Lahontan Regional Water Quality Control Board

MEMORANDUM

SUBJECT: Prosecution Team's Comments on September 1, 2015 Draft Cleanup and Abatement Order (CAO) for Chromium Contamination from the PG&E Hinkley Compressor Station, San Bernardino County

Prosecution Team's Comments on September 1, 2015 Draft Cleanup and Abatement Order R6V-2015-DRAFT

PG&E Chromium Plume Maps Over Time

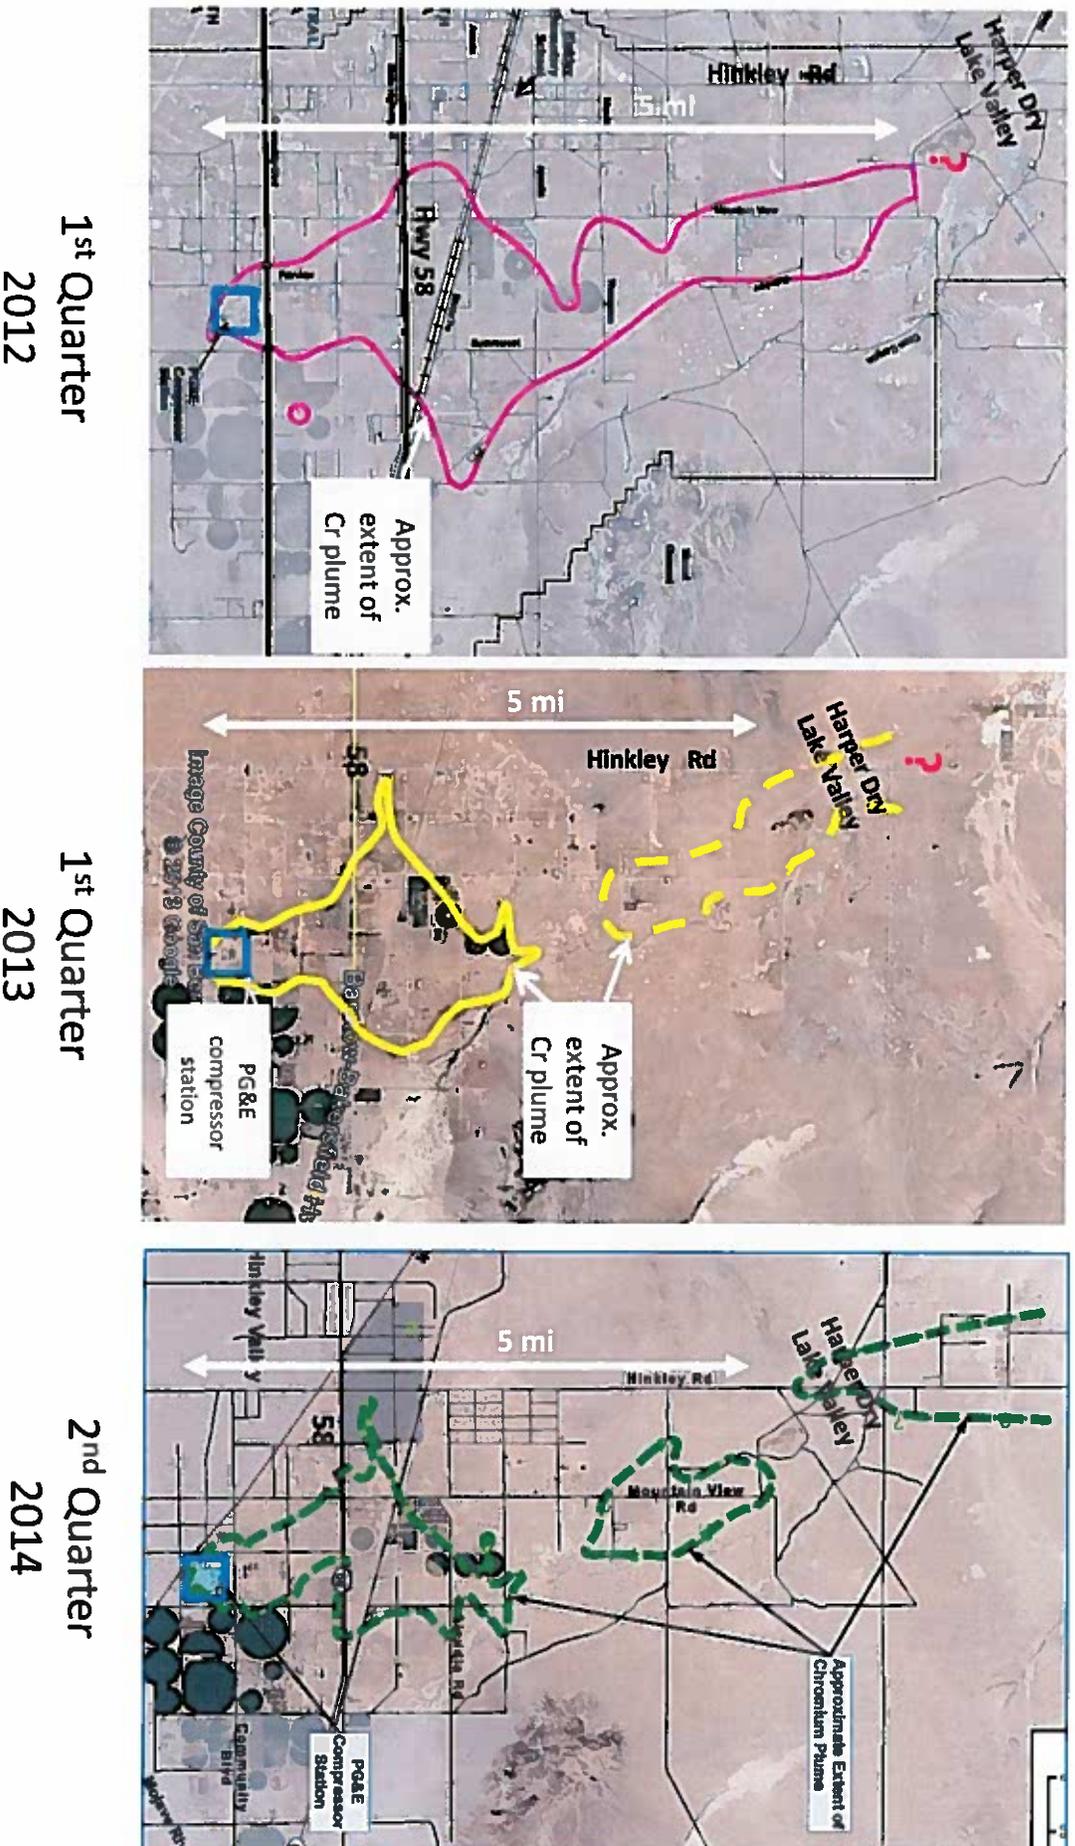
PG&E has claimed that the northern two plumes on current maps are not related to historical chromium releases at the Hinkley compressor station. Yet, as seen in the figure as Attachment 2, the three maps show the progression of the chromium plume over time. Chromium in groundwater was mapped as one large plume connected to the compressor station in first quarter 2012, just 3½ years ago. In 2013, the plume was drawn divided as two separate plumes due to remedial actions. In 2014, the northern plume is shown as divided again but that may just be due to lack of monitoring data in the east side of the Hinkley Gap.

Figure 2.—Study area location.

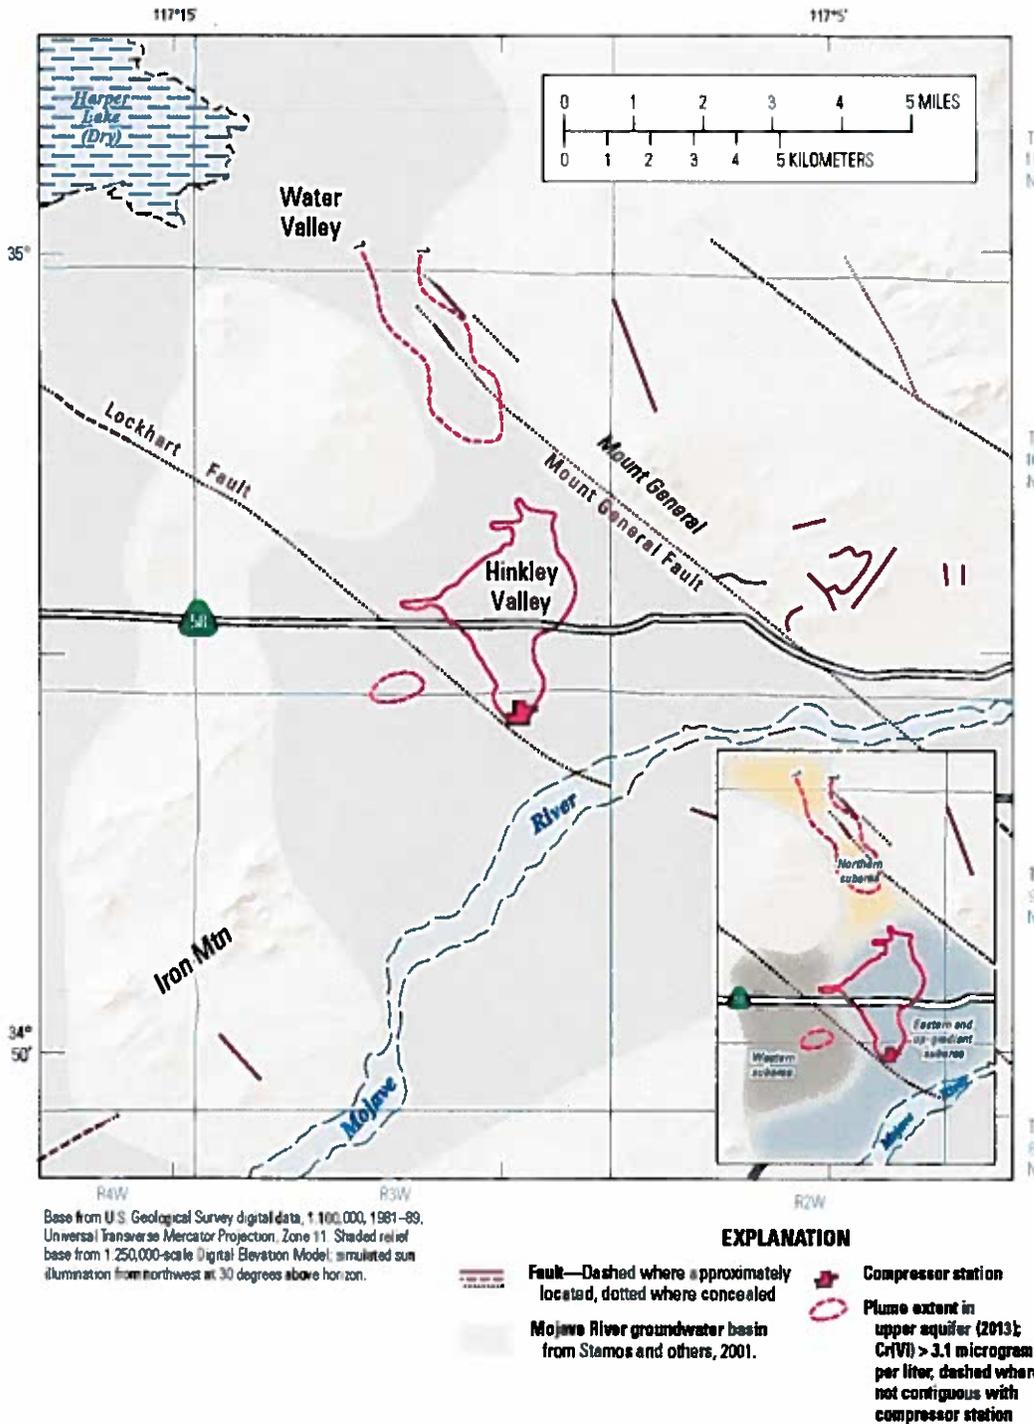
The northern plume is considered as real in the U.S. Geological Survey's (USGS) proposal for chromium background study. The 2014 study proposal includes a map on Figure 2 (Attachment 4) showing the chromium plume boundary lines in groundwater in the North Hinkley Valley and Harper Dry Lake Valley. The explanation for the map states "Plume extent in upper aquifer (2013); Cr(VI) >3.1 micrograms per liter, dashed where not contiguous with compressor station." This latter part indicates the USGS currently considers the dashed plume in the north to be related to the compressor station. The current background study will be establishing just how wide and long the northern plume boundary lines extend.
